Proposal for the 01 Series of Amendments to UN Regulation No. 145 (ISOFIX anchorage systems, ISOFIX top tether anchorages and i-Size)

Submitted by the Working Party on Passive Safety *

The text reproduced below was adopted by the Working Party on Passive Safety (GRSP) at its seventy-third session (ECE/TRANS/WP.29/GRSP/73 para. 43). It is based on ECE/TRANS/WP.29/GRSP/2023/12 as amended by annex XI to the report. It is submitted to the World Forum for Harmonization of Vehicle Regulations (WP.29) and to the Administrative Committee (AC.1) for consideration at their November 2023 sessions.

Figure 1
Lower Tether Anchorage Zone: Side View
 (Dimensions in millimetres)

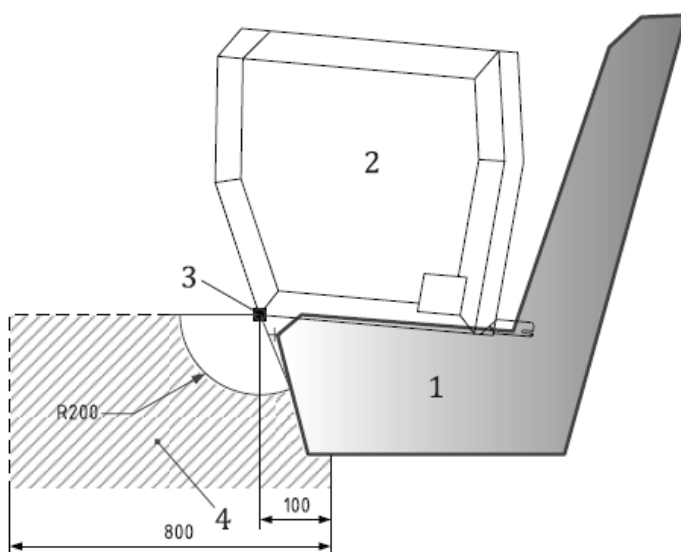
"Annex 6

Lower Tether Anchorage Zone and the Position of the Force Direction Reference Point

- 5.4.2. Number and Positioning
- 5.4.2.1. Each intended (E)CRS position may be provided with a single or two LTAs, located within the zones shown in figures 1 to 3 of Annex 6 and according to the following specifications.

- Key:*
1. vehicle seat illustration.
 2. ISO/R2 envelope installed in related vehicle seating position.
 3. reference point on ISO/R2 envelope for LTA zone measurements.
 4. lower tether anchorage zone in side view, with upper limitation.
 5. where the LTA is integrated with the seat in front, the zone requirements have to be fulfilled independent of the height adjustment settings of the seat in front, taking the presence of the ISO/R2 envelope into consideration.
